First Revision No. 12-NFPA 75-2018 [Section No. 1.3]

1.3* Application.

Figure A.12.1.1.2 Pre-Fire Plan Drawing.

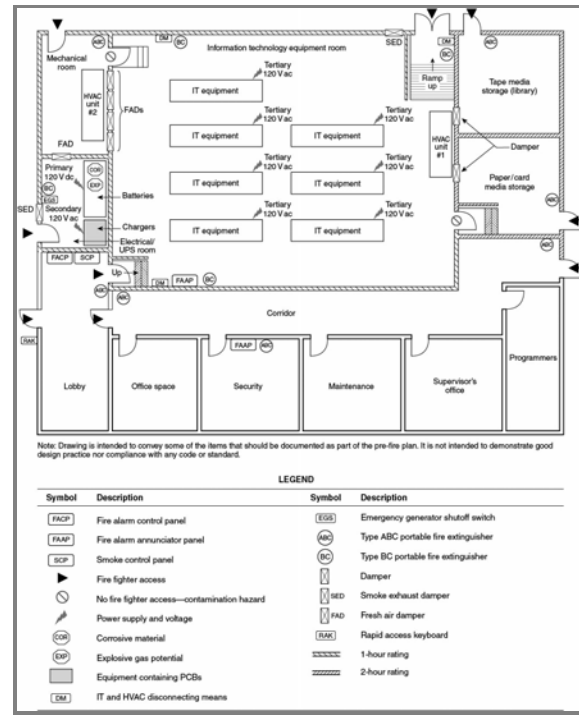
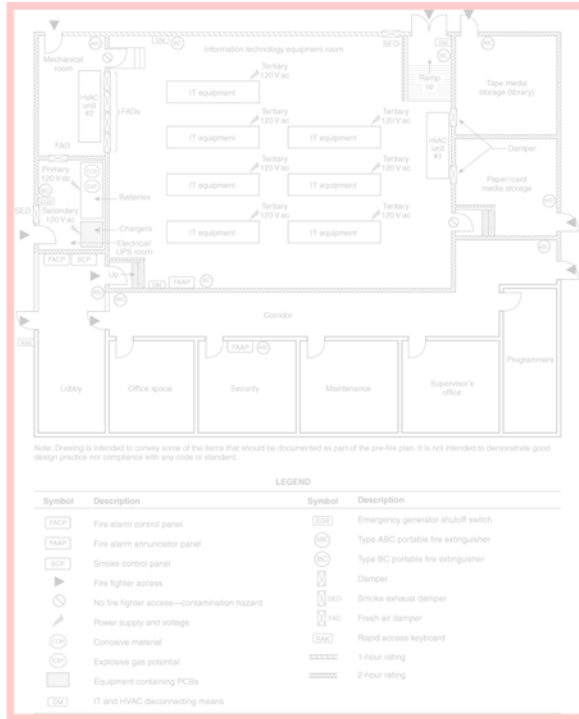
Committee Statement: Revise the figure to better differentiate the 1-hour and 2-hour partition markings as the legend markings did not match those used on the figure.

Fire service orientation and information might include the review of the ITE placement, depowering issues, and how to perform depowering. Additionally, it might be in the best interest of the facility manager to initiate the fire service orientation. Figure A.12.1.1.2 is an example of a pre-fire plan drawing.
